Re: Island Bay Cycle Lanes

This submission is from the Architectural Centre, an incorporated society dating from 1946, which represents both professionals and non-professionals interested in the promotion of good design.

3. This submission addresses the proposed detail of the Island Bay Cycle lanes design. In making these comments and suggestions, we do not resile from our previous comments - but instead offer them with the aim of making the current proposal the best that it might be. We sincerely believe that, in order to justify claims made by supporters of this initiative, the design must be exemplary. Care with design is especially critical given that the remainder of the route into the CBD is yet to be designed. To have compromised design within the voluptuous widths of Island Bay's Parade would be a travesty.

Figure 1: Existing Dee St/Parade intersection with roundabout

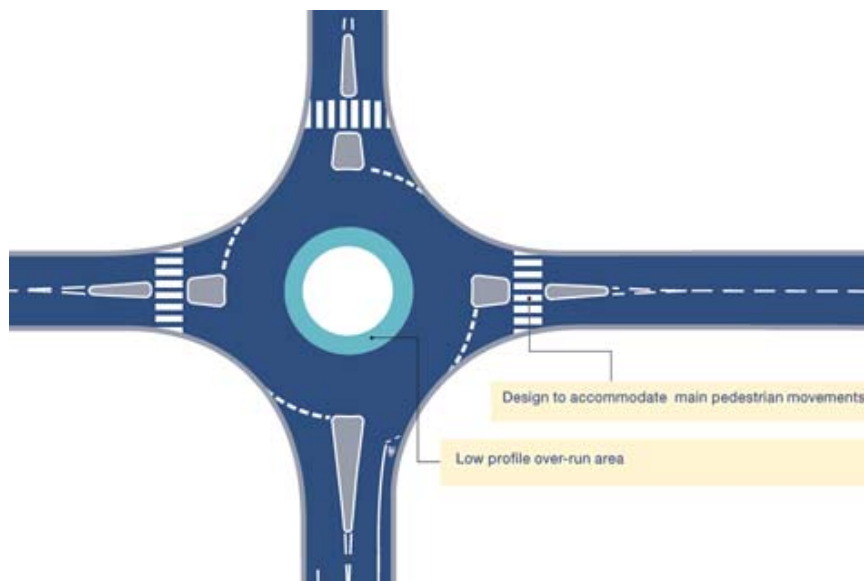
9. The consultation documents propose to replace the Dee St roundabout with traffic signals.¹² The Centre considers that this proposal is erroneous. While it is true that large multi-lane roundabouts with high traffic volumes can be difficult for cyclists and pedestrians,¹³ this is not the situation at this intersection, where traffic self-regulates efficiently. In addition, single-lane roundabouts (or traffic circles) are known to operate as traffic calming measures, improving safety for cycling.¹⁴

10. In fact the Dee St/Parade intersection roundabout is almost a model example of a roundabout designed for cycling, and compares well with the Sustrans recommended practice of the "Compact/Continental Roundabout" (Fig 2).¹⁶ According to the Netherlands Institute for Road Safety Research (SWOV), roundabouts are generally safer than four-way intersections because "they reduce the number of potential conflicts between road users and lower the

11. Based on this research, and our personal cycling experience using this roundabout, the Centre considers that introducing traffic signals will simply create an inconvenience rather than improve the transport circulation and safety, and will only cause time penalties for most users without providing any benefits.

Recommendation 1: Retain the Dee St roundabout.

Figure 10: Island Bay proposal

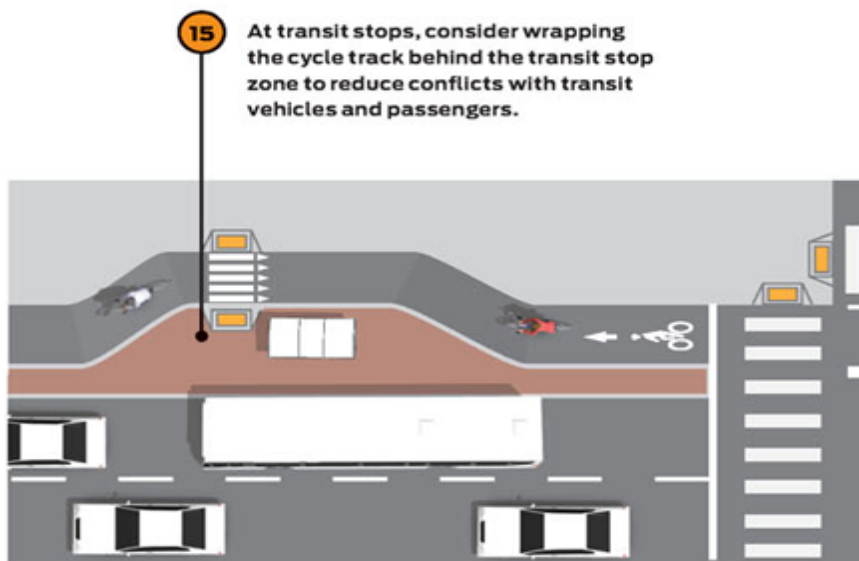
32. The Architectural Centre believes that requiring cyclists to give way to pedestrians will be negative for commuter cyclists. The Island Bay bus patronage is the already amongst the highest in the city (747 people in the 2013 census in the morning peak; 2.86 times cyclists; 17% more than the city's average), so The Parade and Adelaide Rd are likely to have more people on footpaths waiting for buses than other parts of Wellington. In addition, the proposal notes that GWRC is planning on reducing the number of bus stops, which will increase the number of people waiting at bus stop, increasing likely

Recommendation 10: Abandon the bus stop island idea.

Recommendation 11: Give cyclists priority over pedestrians at bus stop cycle ways. Pedestrians are there to wait for buses, so will not be inconvenienced. Cyclists are there to commuter, so disruptions are significantly adverse.

Recommendation 12: Ensure a very clear contrast of paving surfaces is used to warn pedestrians of the cycleway. Smooth road surfaces should be provided for cyclists to increase the comfort of their ride. Kerbs should be used to signal to pedestrians that cycleways are roadways and priority is to be given to cyclists.

Recommendation 13: The proposed design for the cycleway must be increased in width so it is significantly wider than the undernourished 1.2m indicated.

Fig 12: Island Bay proposal (Humber St to the right of the image)

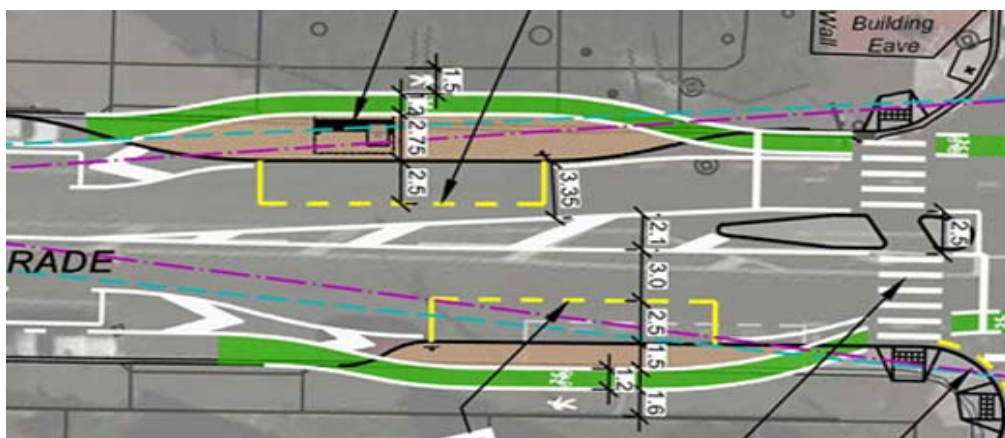
34. Given the row of parked cars obscuring cyclists from car drivers, we imagine the comments regarding driveway conflicts to be highly relevant. We are also conscious of the increased danger of mixing pedestrians and cyclists because of the lack of attention that increasingly pedestrians pay to vehicles - a recent example being the Bond St problems - in part because an increasing number of pedestrians are glued to their mobile phones oblivious of their immediate environment, including the relative silence of cycle travel.⁵²

35. We consider that this design will create additional disruptions to commuter cyclists, as well as causing cyclists to need to ride at slower speeds; these together will reduce the appeal of this route for commuter cyclists, because it will be slower than at present. This contradicts a basic philosophy recommended in cycle design, articulated by Sustrans: "designs should send the message that cyclists are at least as important users of the highway network as motor traffic, with cyclists being given an advantage in terms of directness and priority where possible."⁵³
